SAND DUNES/MOJAVE FRINGE-TOED LIZARD MITIGATION

DOCKET	
09-AFC-8	
DATE	<u>05/18/10</u>
RECD.	<u>06/02/10</u>

GENESIS SOLAR ENERGY PROJECT RIVERSIDE COUNTY, CALIFORNIA

Biological Survey Results for *Uma scoparia* and *Cryptantha costata* and Natural Community Types

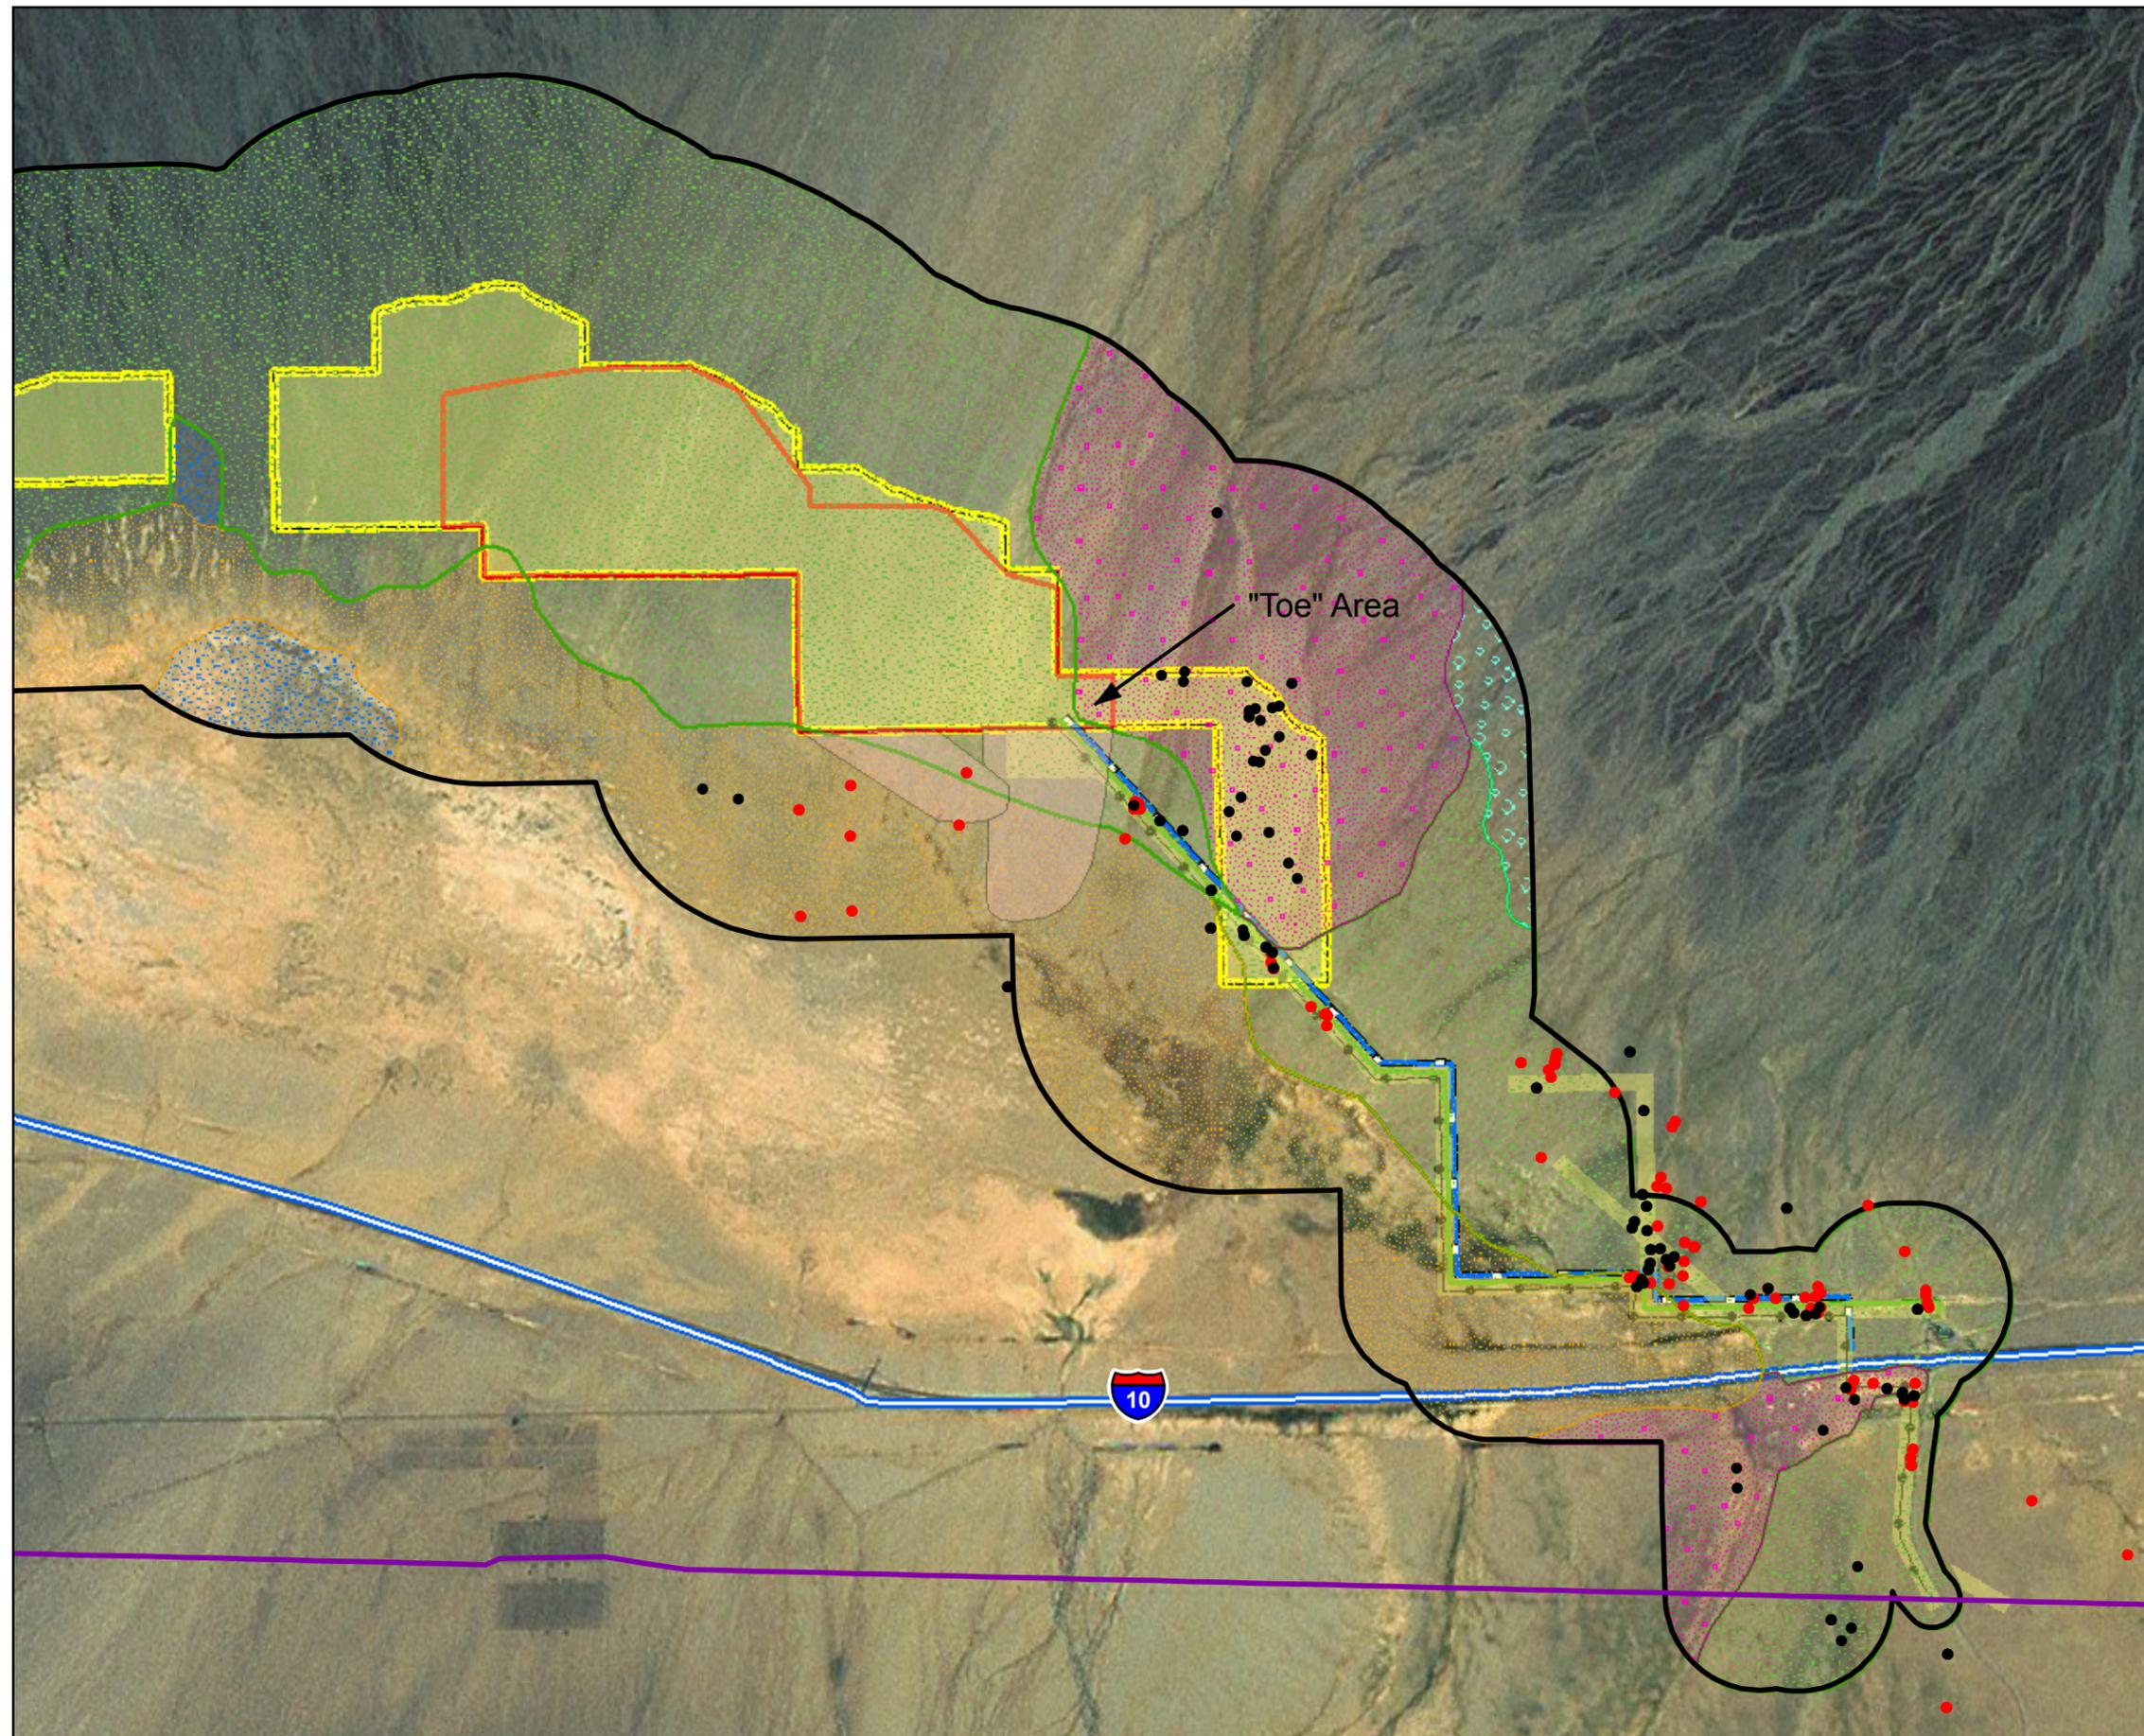
Comment: The Applicant agrees with the 3:1 compensation for direct Project impacts to sand dune habitat, but disagrees with any additional mitigation requirements. Because the Applicant has agreed to drop the easternmost portion of the Plant Site (41.4 acres), the acreage of direct impact to sand dunes by the Plant Site would be eliminated. Project impacts to the sand dunes would be reduced to 0.8 acres, the entirety of which is located along the Linear Facilities. At 0.8 acres of direct impact, the compensation requirement would be 2.4 acres.

Mojave fringe-toed lizards are dune and loose-sand specialists. Mojave fringe-toed lizard sightings during intensive, focused surveys in both 2009 and 2010 that included 100% of the Project Area, 100% of an extension south of the Project Area in the area CEC Staff has indicated as a potential sand shadow area, and buffer transects extending outward from all 100% survey areas (see attached Figure; TTEC and Karl 2009) show that this species is most closely associated with Stabilized and Partially Stabilized Sand Dunes on and around the Project Disturbance Area.

To augment the potential identification of Mojave fringe-toed lizard habitat, observations of ribbed cryptantha (*Cryptantha costata*), also a loose sand associate, were mapped with those of Mojave fringe-toed lizard (see attached Figure). Assuming that both species adequately identify loose sand that could be occupied by Mojave fringe-toed lizard habitat, it can be seen that there is no suitable habitat for Mojave fringe-toed lizard habitat in the area south of the eastern toe of the Project Disturbance Area in the area the CEC identified as a potential eastern sand shadow, and very minimal habitat (one drainage) in the area the CEC identified as a potential westerly sand shadow. Based on these associations, there is little potential for direct or indirect impacts to Mojave fringe-toed lizard in the areas that CEC staff designated as potential sand shadows.
